**SECTION 00 90 01  
BIDDING AND CONTRACT REQUIREMENTS  
ADDENDUM NUMBER (1)**

Issued: October 17, 2018

**Re: ADDENDUM NUMBER (1) TO THE BIDDING DOCUMENTS FOR**

**McHenry County College  
Buildings A & E Renovations – BP2  
Architect's Project Number: 18-001**

10/13/2018 5:50:56 PM

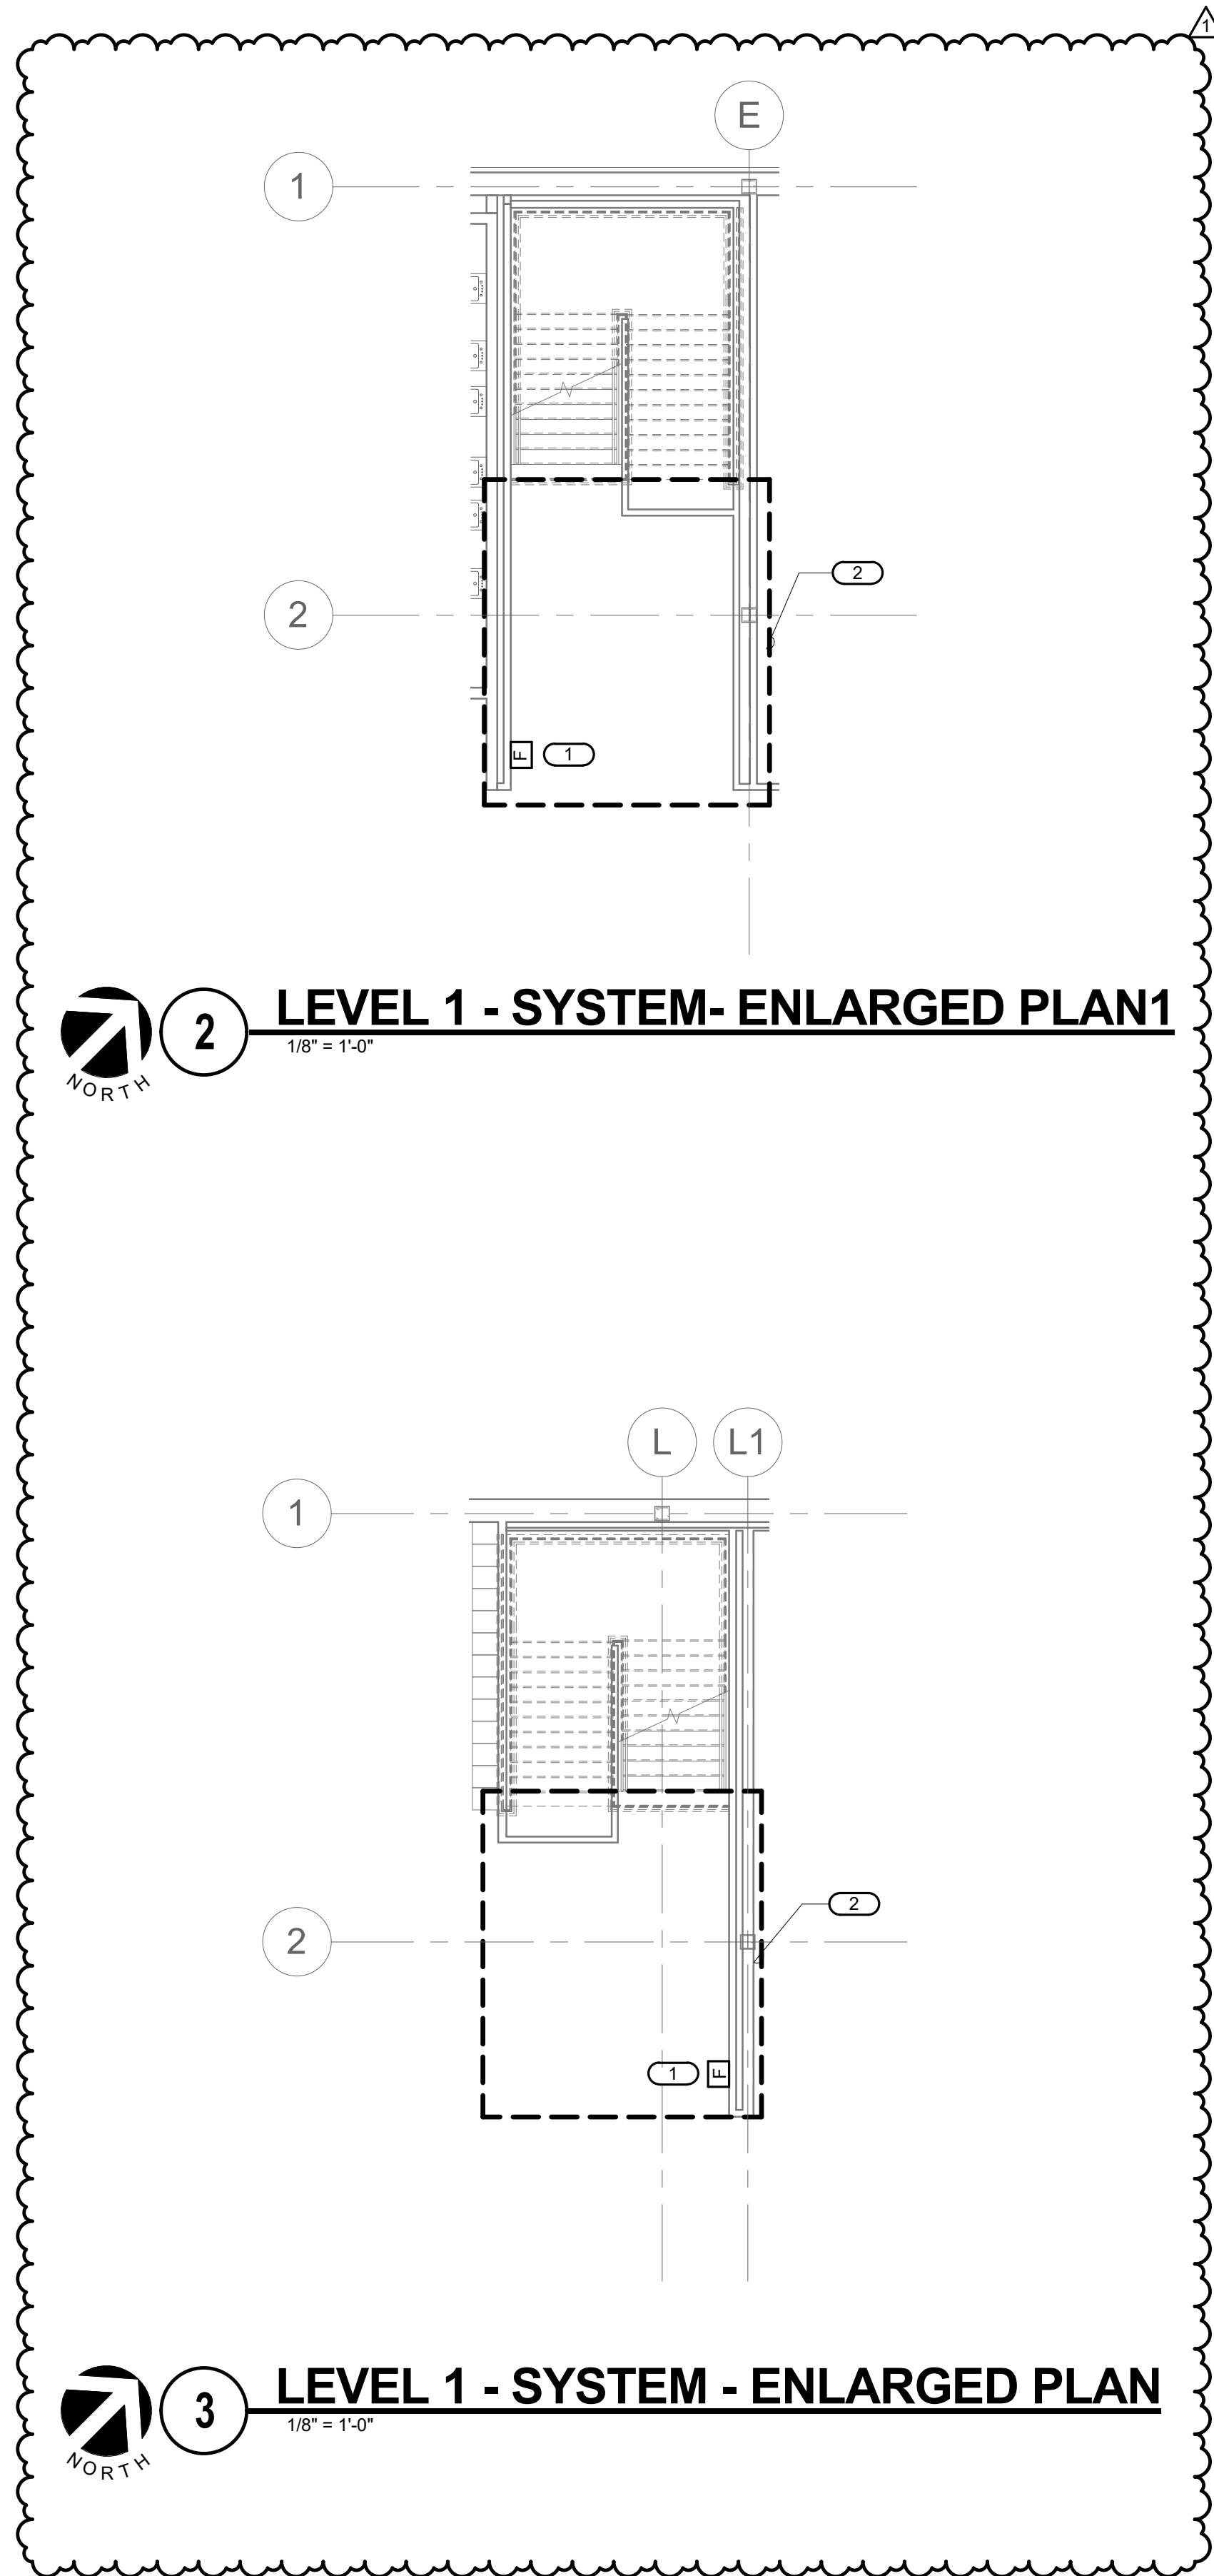
1. ED1.21
  - A. **REVISE** scope of work as shown in enlarged plans 2/ED1.21 and 3/ED1.21.
  - B. **REVISE** keynotes as shown.
2. E1.10
  - A. **REVISE** plan reference tags as shown.
3. E1.21
  - A. **ADD** keynote #8 in enlarged plans 2/E1.21 and 3/E1.21.
  - B. **REVISE** keynotes as shown.
4. E3.21
  - A. **ADD** work scope as shown in enlarged plans 2/E3.21 and 3/E3.21.
  - B. **REVISE** keynotes as shown.

**FP1.21**

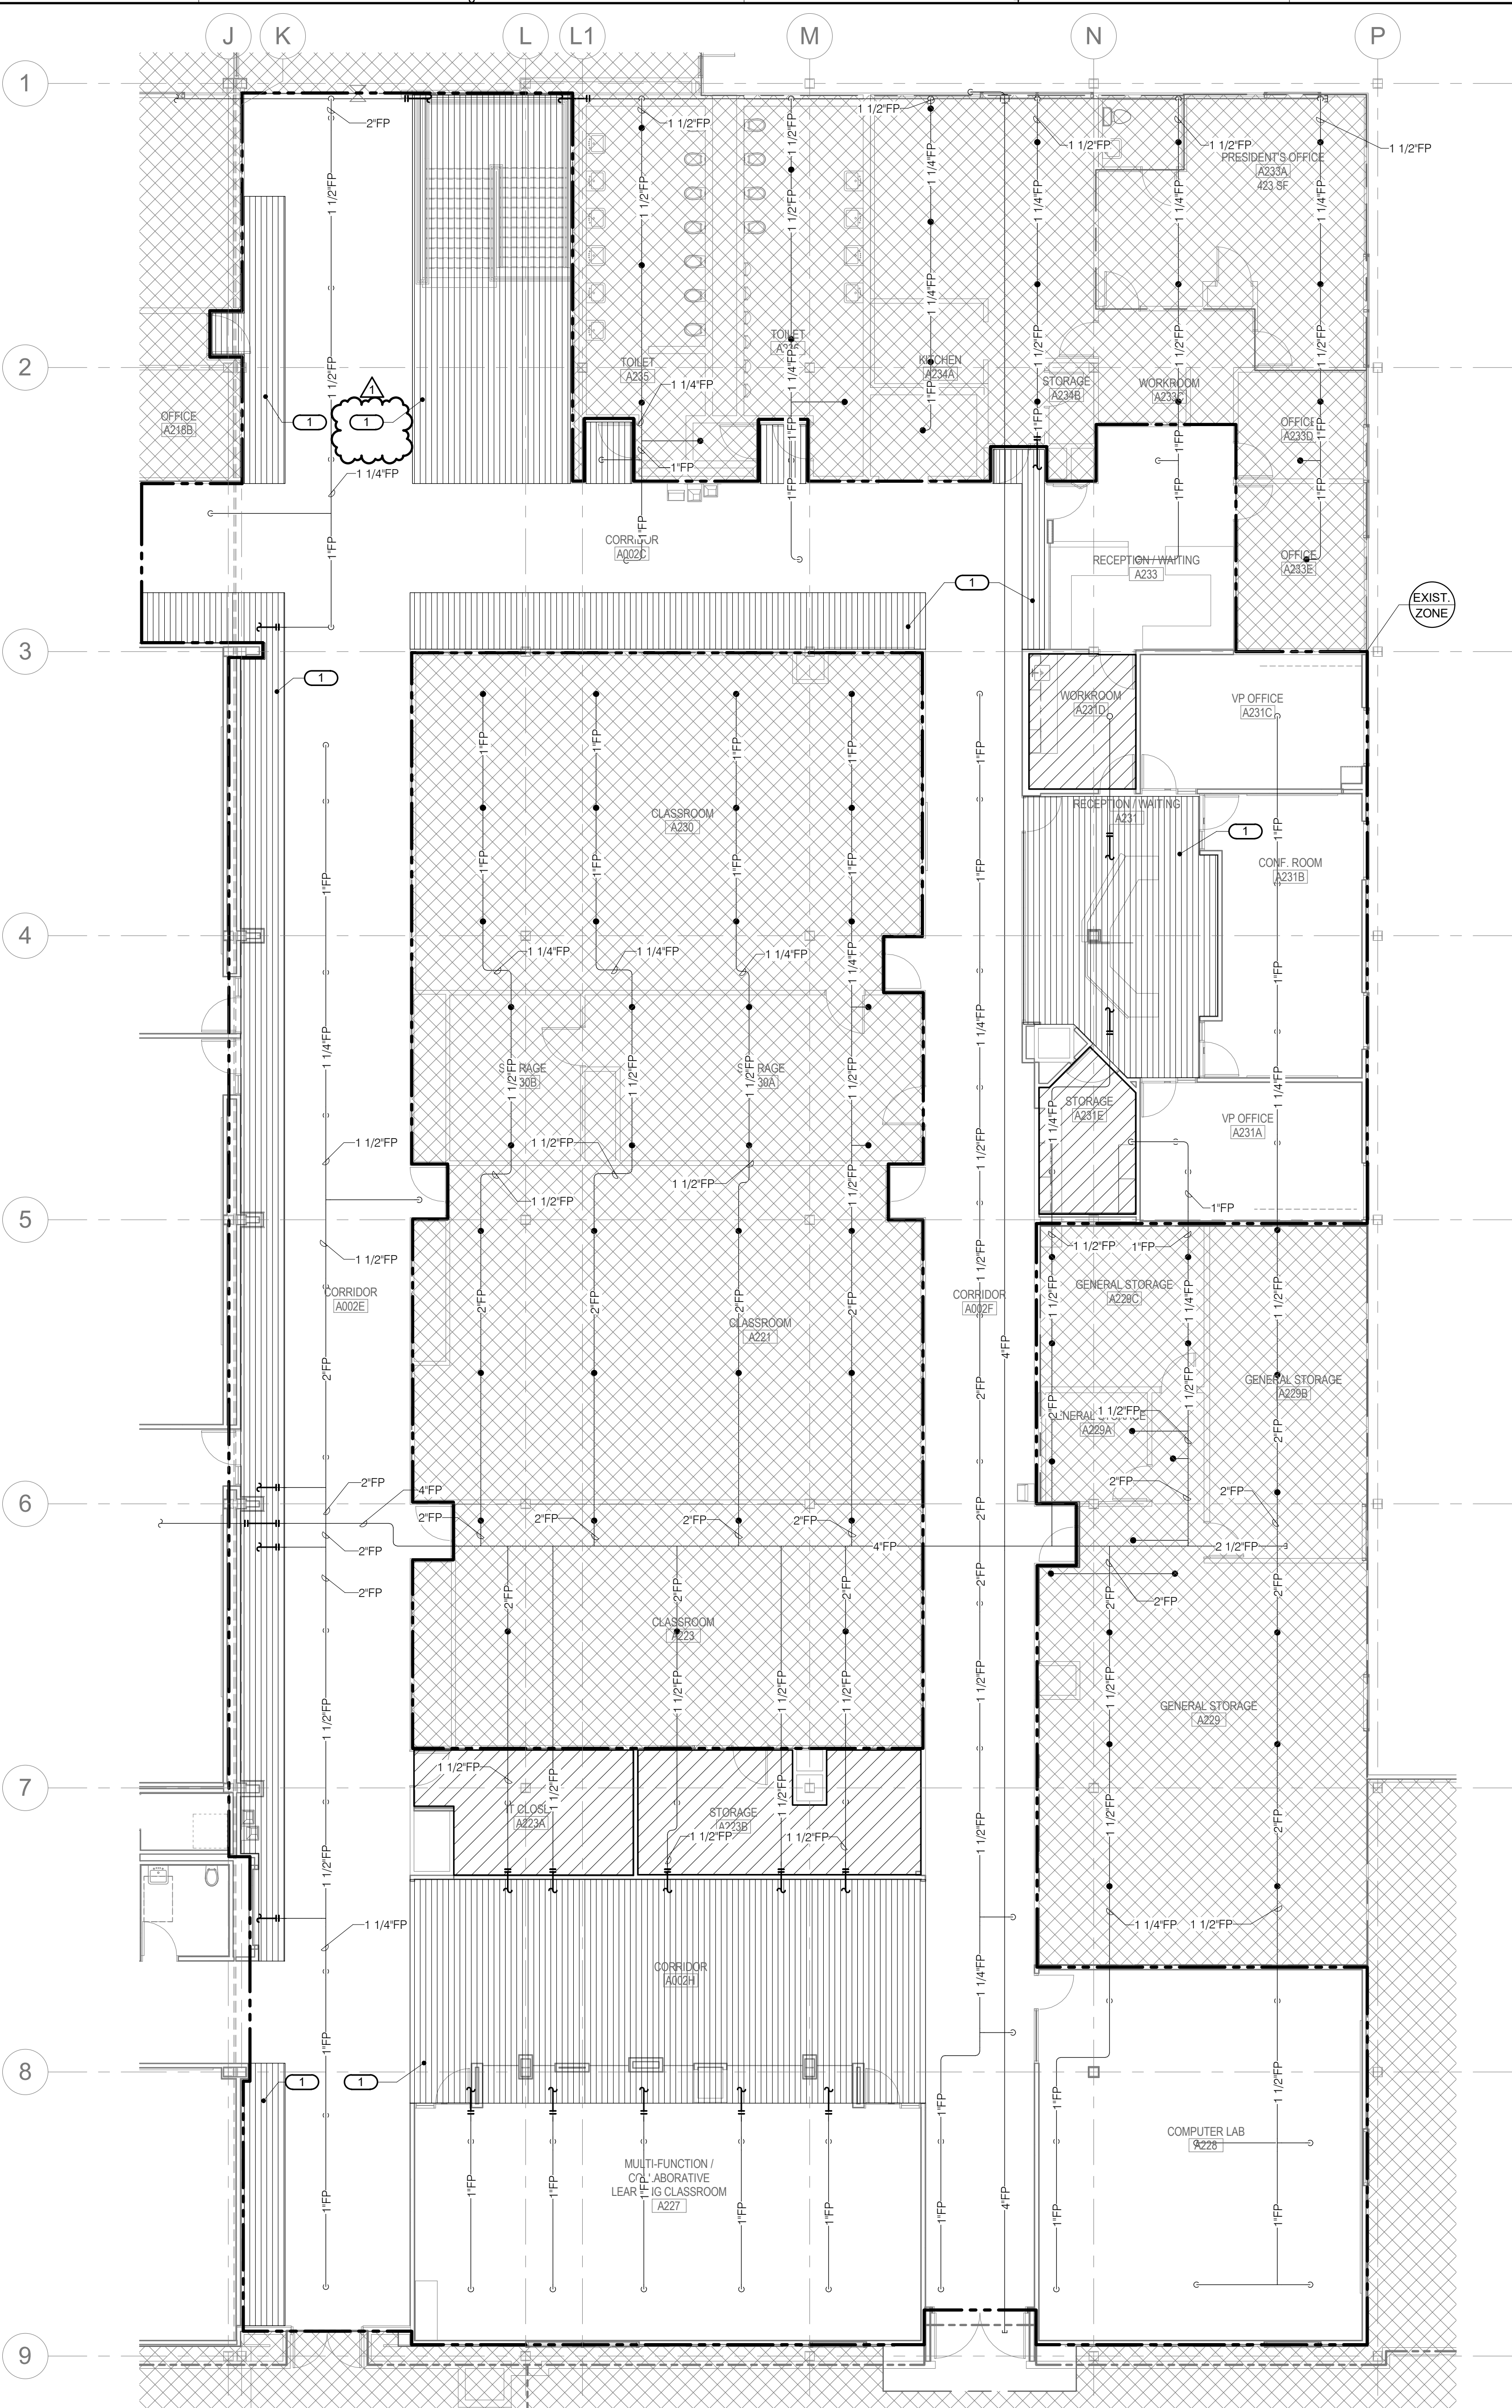
1. FP1.21
  - A. **REVISE** scope of work detail for Bid Alternate #5. Added view detailing location and scope of work area.
2. FP1.22
  - A. **REVISE** scope of work detail for Bid Alternate #5. Added view detailing location and scope of work area.
